DATE: 05/31/2022

PROJECT: Washington Township Fire Station 41

ADDENDUM NO. 3

DATE 3/22/2022
 JOB NO. 3952.00
 DRAWN DEG
 CHECKED JDZ
 COPYRIGHT © 2022 - App Architecture, Inc.
 TITLE
LEGENDS AND SCHEDULES
 SHEET NO.
P0.1

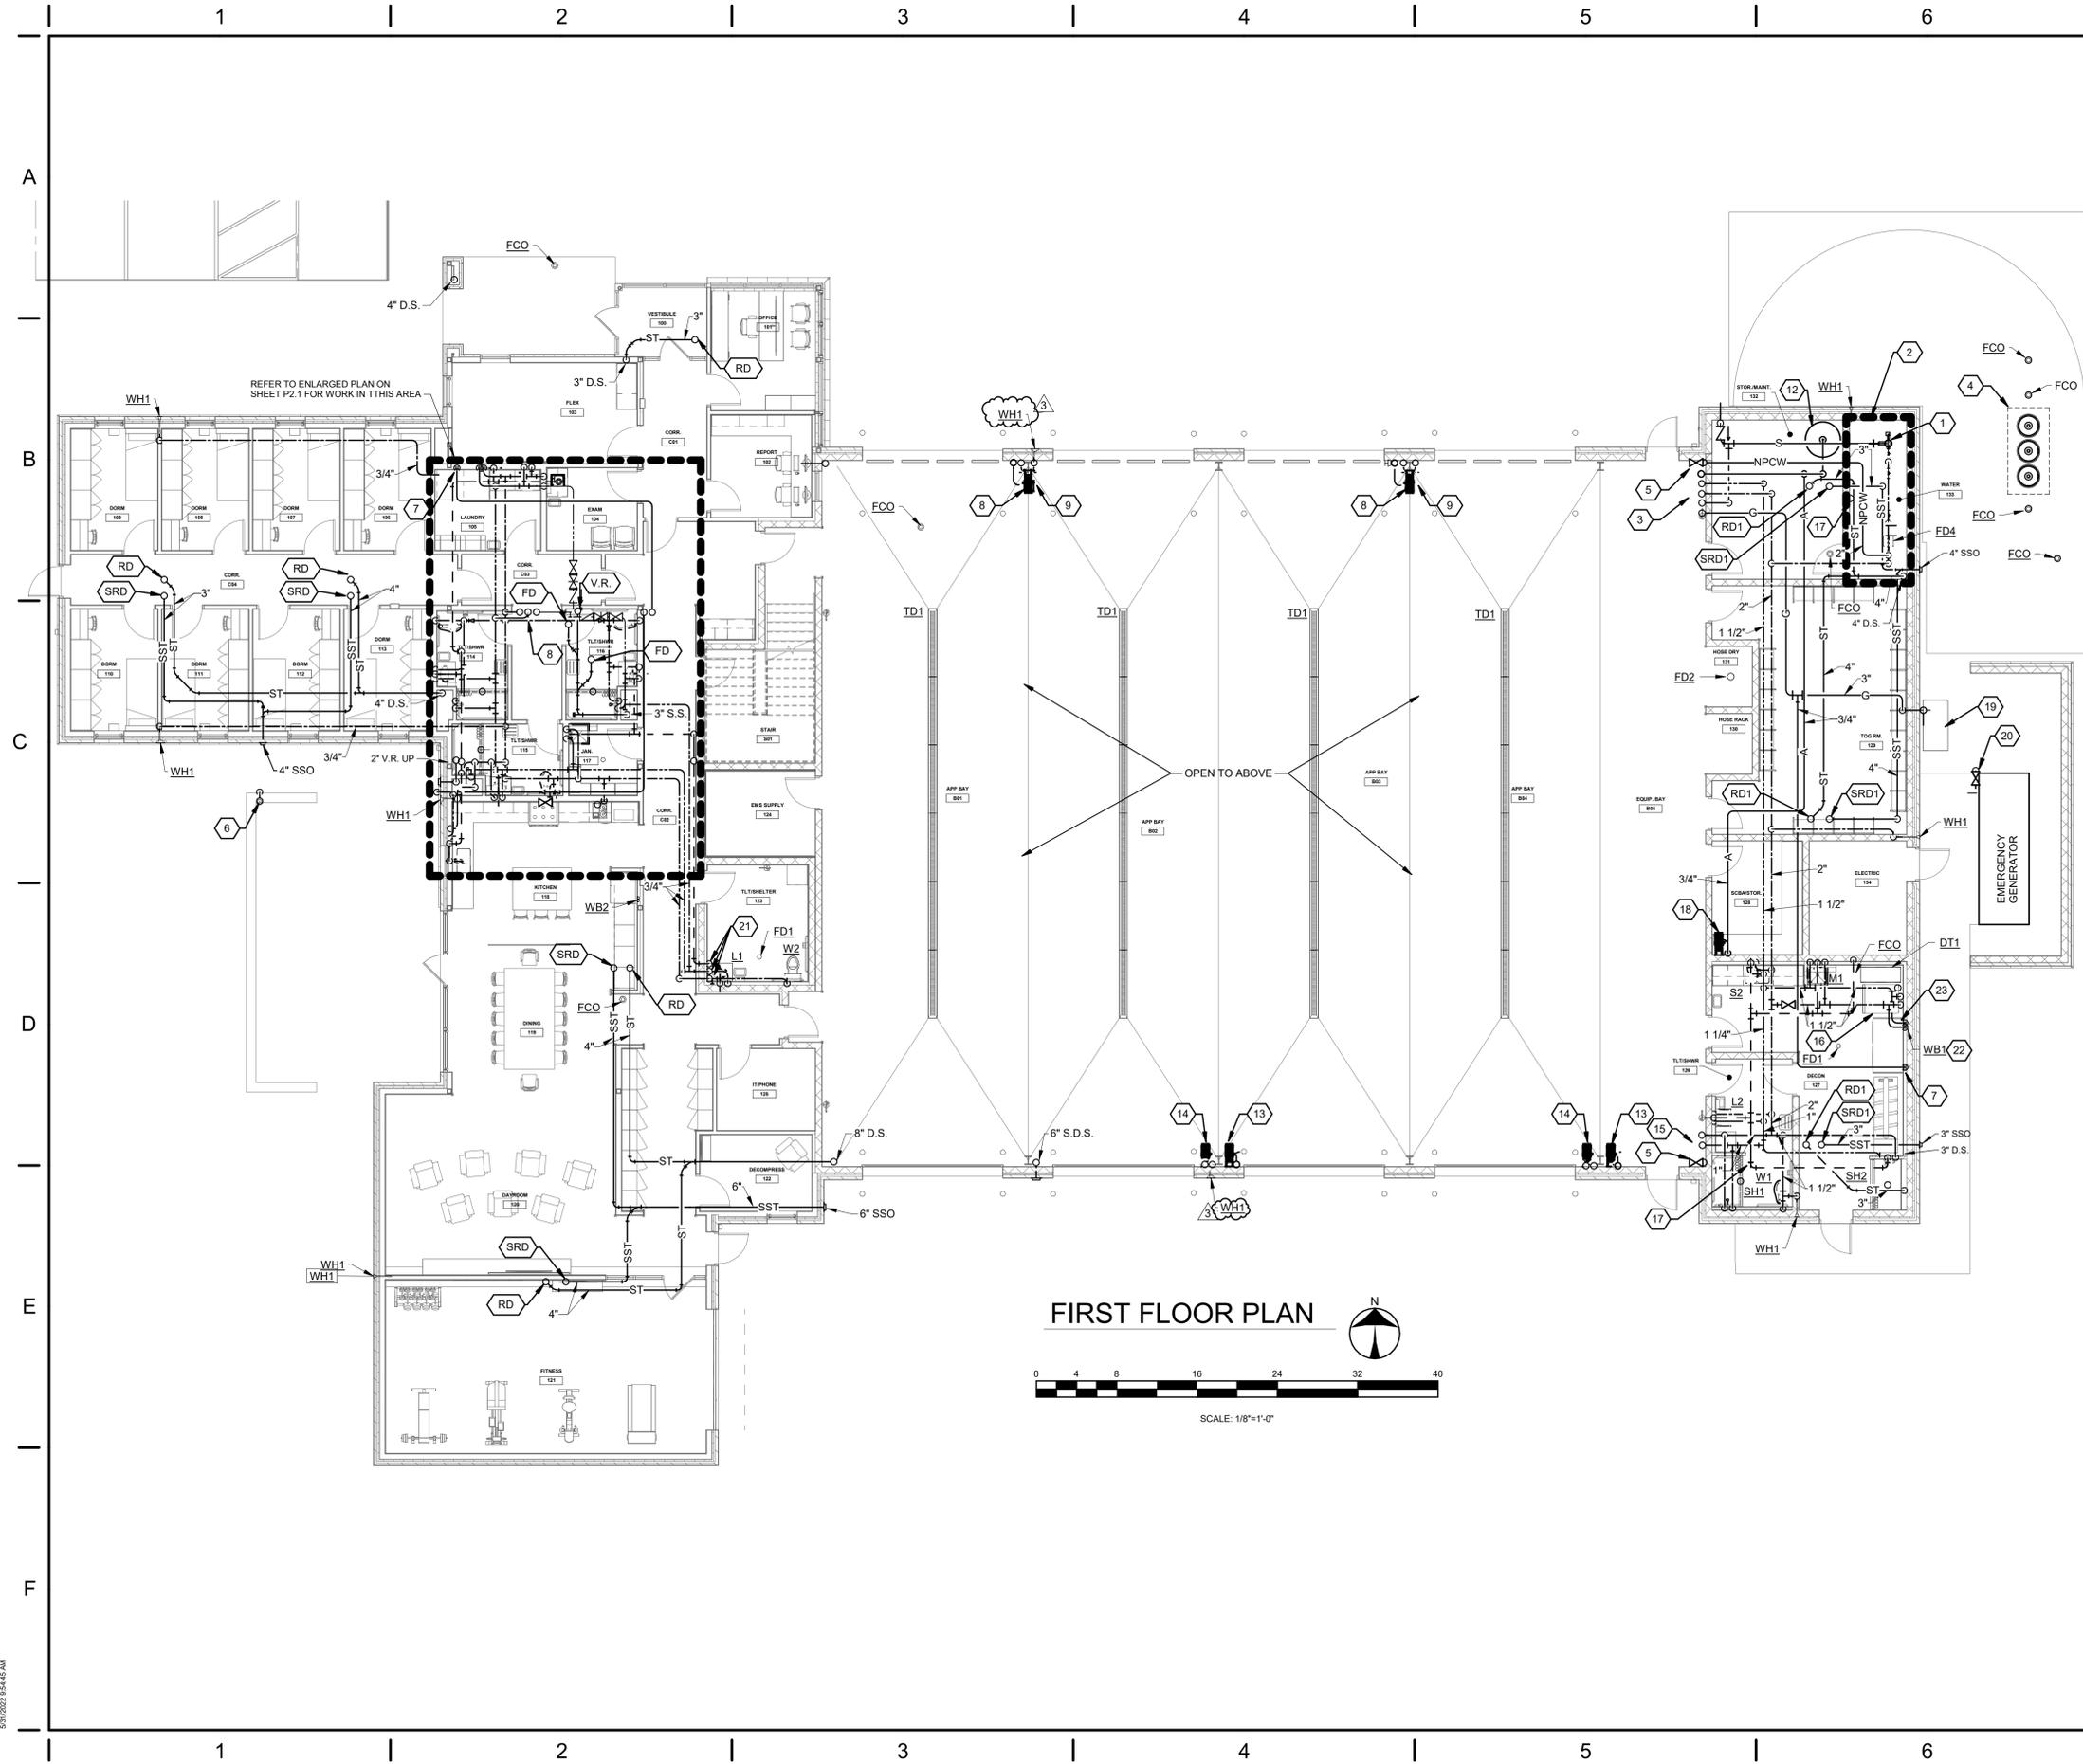
ITEM P5 SHEET P0.1

1. Plumbing Fixture Schedule – Add “WH1” per attached drawing.

SHEET NO.
H0.3

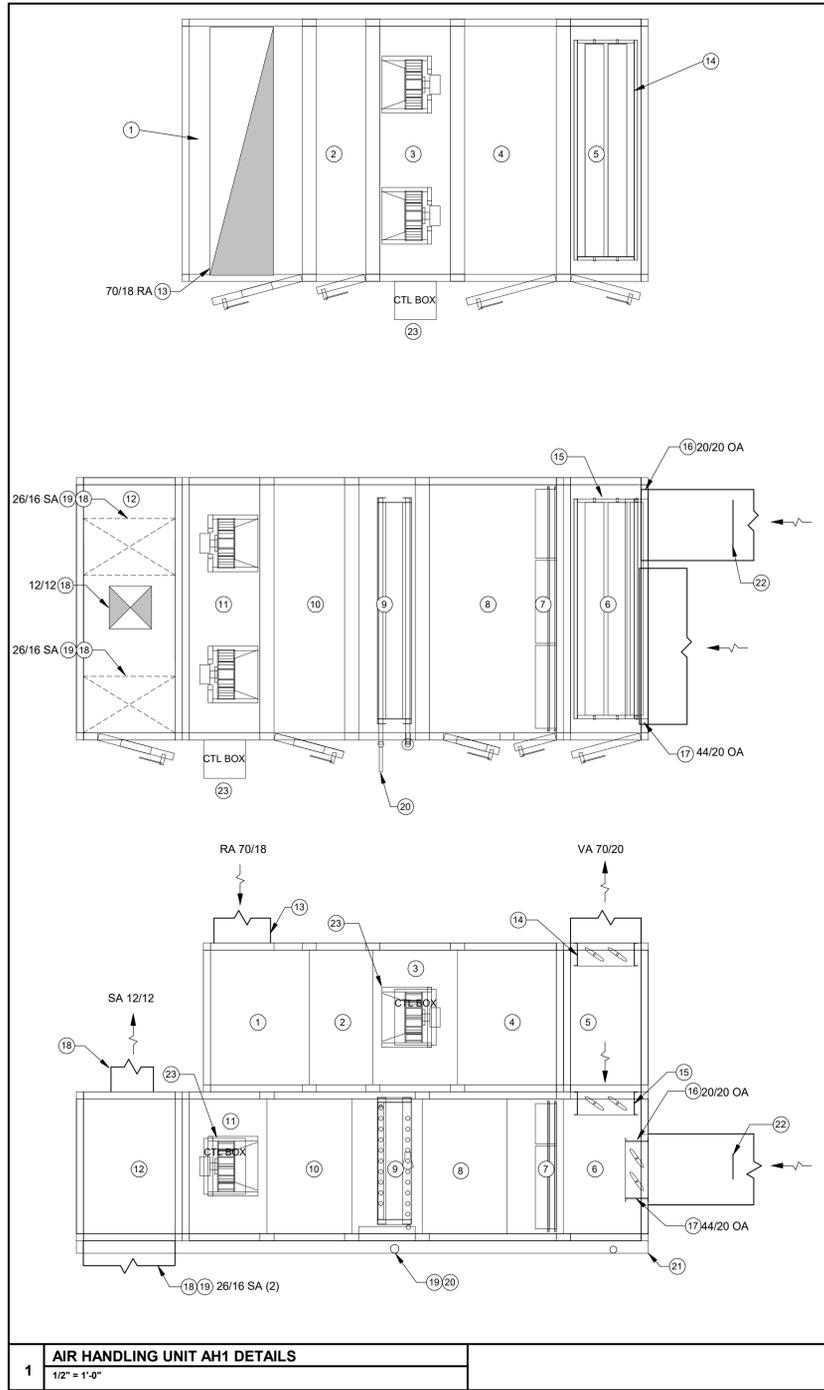
ITEM H7 SHEET H0.3

1. Air Handling Unit AHU-1 Schedule. Add Note 3. Provide alternate price for direct drive plenum fans with VFD (Supply and return fan arrays). See specifications.

- NOTES:
- REFER TO PLAN AND ELEVATION DRAWINGS FOR COMPONENTS AND ARRANGEMENT.
 - PROVIDE ADDITIONAL 120V/1Ø CIRCUIT TO POWER LIGHTS BY E.C.
 - PROVIDE ALTERNATE PRICE FOR DIRECT DRIVE PLENUM FANS WITH VFD (SUPPLY AND RETURN FAN ARRAYS). SEE SPECIFICATION.
